OLYMPIC TOWER

715 8TH AVE. SEATTLE

DESIGN RECOMMENDATION
EAST DESIGN REVIEW BOARD
12 DECEMBER 2018
DPD #3028357-LU

2.GROUND FLOOR INTERACTION
BETWEEN BUILDING AND LOBBY:

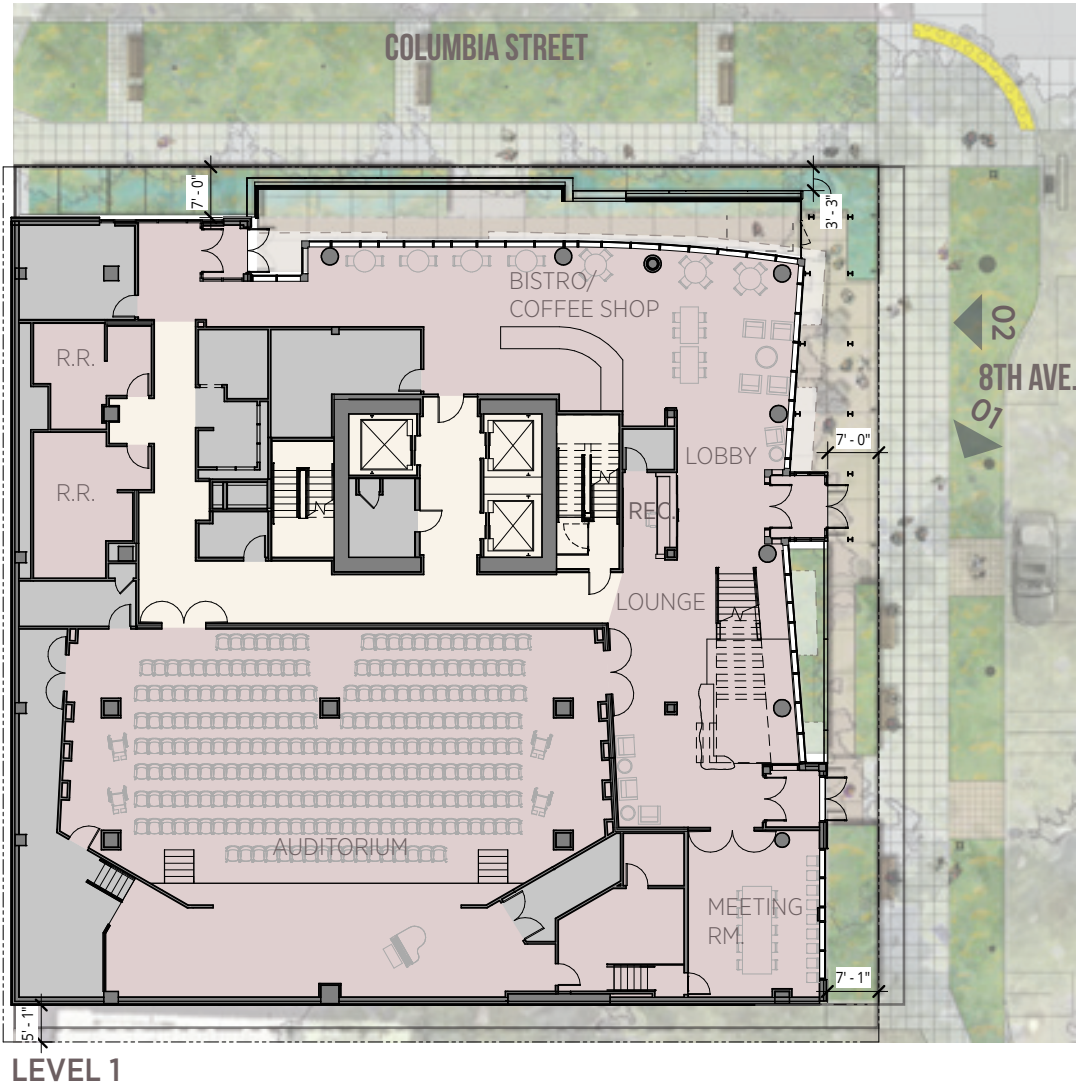
BOARD COMMENTS

The Board supported, and was interested in seeing, more development in the lobby and lounge internal spaces and the outdoor courtyard and 8th Avenue.

a. The Board asked for clarification of the uses along the ground floor and their interaction with the public right of way. A smooth transition from sidewalk to courtyard to internal spaces (sidewalk to the lounge) is supported by the Board. (PL3 A,D; DC1A)

Board note: The Board remained neutral on the skybridge proposal. They asked skybridge related questions including a query to determine if it was situated too low on the buildings and too close to the street which seems to press down on the public realm. They noted that in good rban design there would be no skybridge, but strong attention to the ground plane and well-planned, public realm comfortable circulation.

The ground floor uses are performance hall, bistro, lounge, reception, meeting room and a salon. Since this is a senior housing project, residents will be occupying the ground level uses during both day and night to activate the street level. The tower corner that erodes the podium turns into a 2 story glass wall that visually connects the interior and exterior. This corner also has covered exterior seating, a rainwater feature incorporated into an entry canopy that fills the bioretention planters that cascade down Columbia Street. Columbia Street also has handrails and areas to stop and sit. Generous setbacks along 8th Ave allow for seating, and a large planter with seating that visually connects the exterior and the interior.

3. RESIDENTIAL CHARACTER:

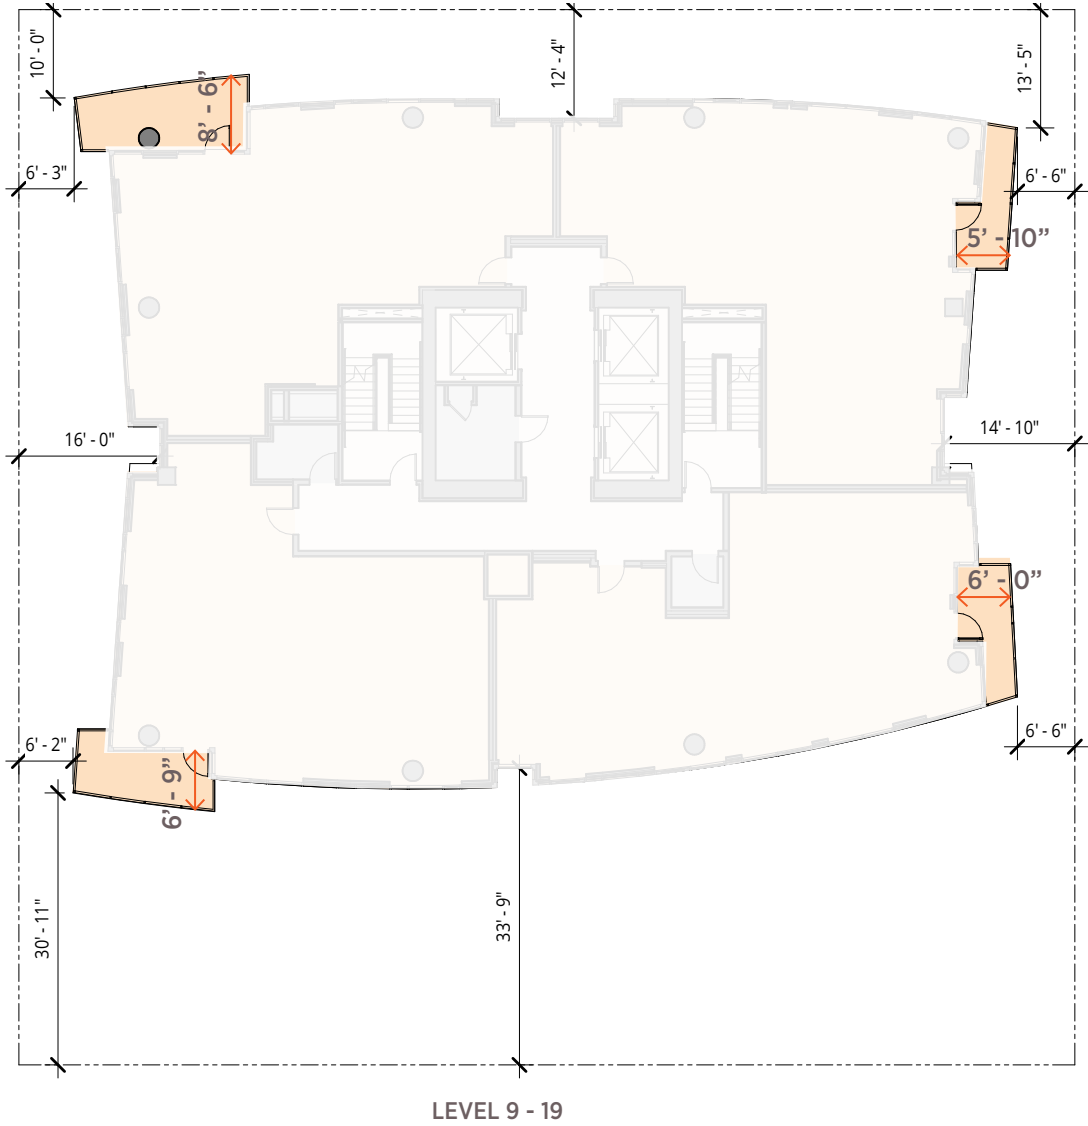
The Board focused on guidance to help the building exhibit a strong residential character.

a. Enhance building elements that communicate the residential use of the building. For instance, include residential balconies on the tower. They may be recessed to preserve tower architectural lines, but they should be useable for residents. The Board supported the initial views of transparent balconies and balconies with a sense of depth, that is, four to six feet deep. The Board suggested more design language to enhance and denote the residential use from top to bottom. (CS2C,PL3, DC2E; DC4C)

To communicate the residential use, balconies have been added at all units in the tower except for the lower 4 floors at the NE corner that erodes the podium. The balconies are partially recessed and partially extend past the glass façade to provide usable depths. Residential units on the 3rd floor are provided with large terraces recessed into the podium. The lounge at the top floor is differentiated from the residential uses by creating a glass box framed by the metal panel.

1. PARKING AISLES

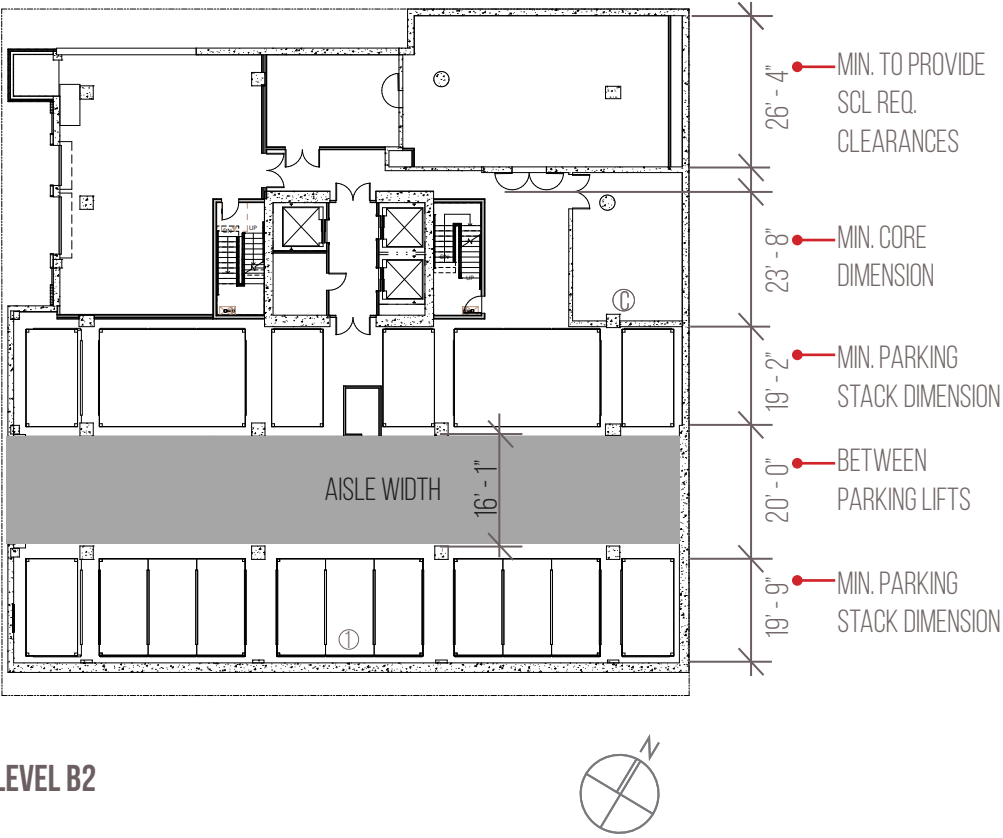
The board indicated they were willing to support the departure.

Project proposes 16'-1" clear aisle width between structural columns and 20'-0" clear between parking lifts.

Access to parking is located off the Alley with a single point of entry to minimize conflicts between vehicles and non-motorists. Valet parking is used for all parking on site to further minimize conflicts that could otherwise arise from individual resident parking.

The building footprint has been reduced to the extent possible while meeting minimum dimensions allowable including Seattle City Light minimum vault clearances, building structural core, and parking spaces. The parking lifts and narrow drive aisle allow the garage to be located further away from Columbia Street to allow depth for the salon along the street frontage. The parking area is located below grade and areas that are above grade are enclosed minimizing visual impact.
